CHILDREN'S HOSPITAL
OF ORANGE COUNTY

TOWER II

LEVEL 1 MECHANICAL PLAN
AREA - D

M3.1D

LEVEL 1 MECHANICAL PLAN AREA - D

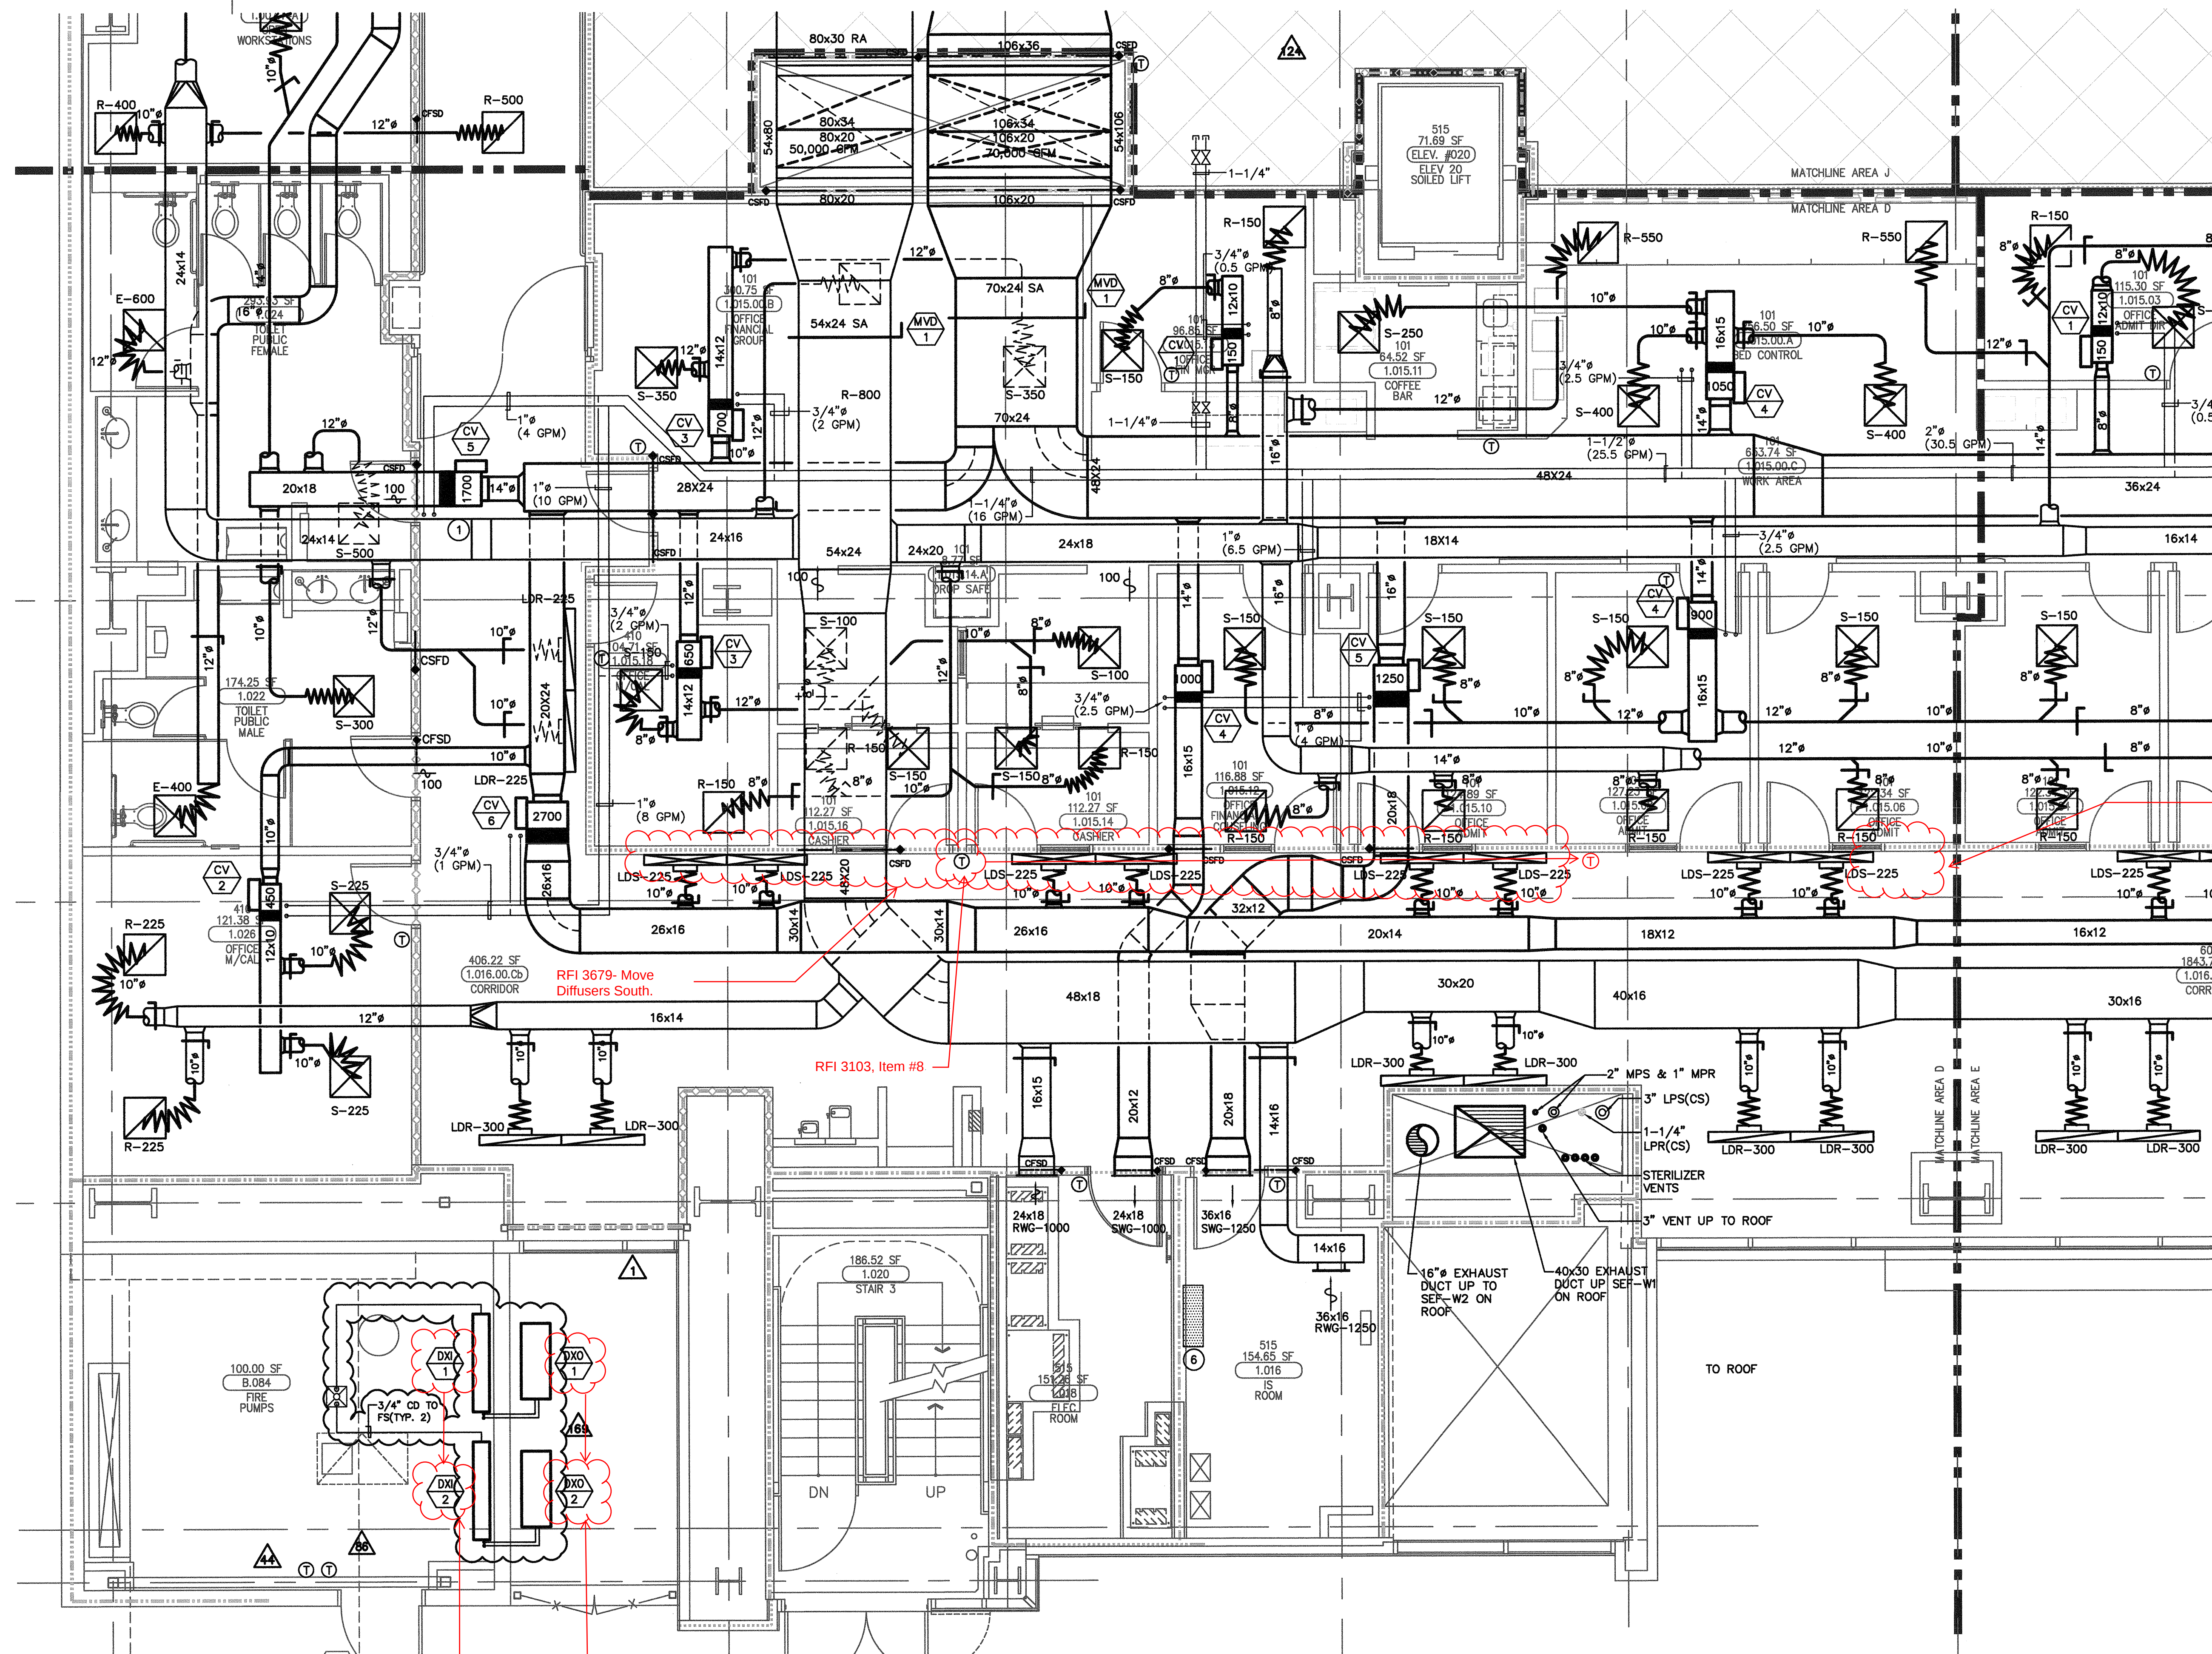
RFI #4540
Units to be
mounted at 7' AFF.

RFI #4540
Two DXO units serving
the fire pump room
have been relocated to
the roof.
